Adury Apparels Ltd (Extension-02)

9 November 2023

Structural Inspection Report

Typical Floor layout plan

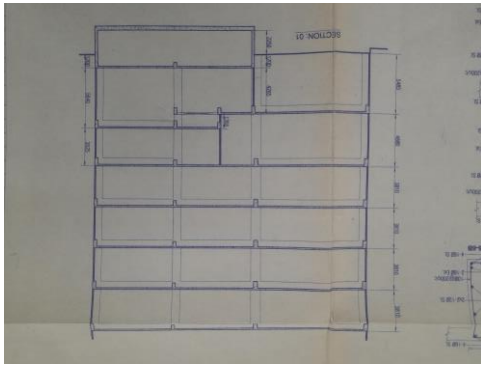
Observation-1: Lack of information in as-built drawing. (Building-5)

Description: During inspection, only floor layout plan was provided in available as-built architectural drawing. No elevation view and sectional details were provided. Building engineer is required to update as-built drawing incorporating all architectural details of this Building.
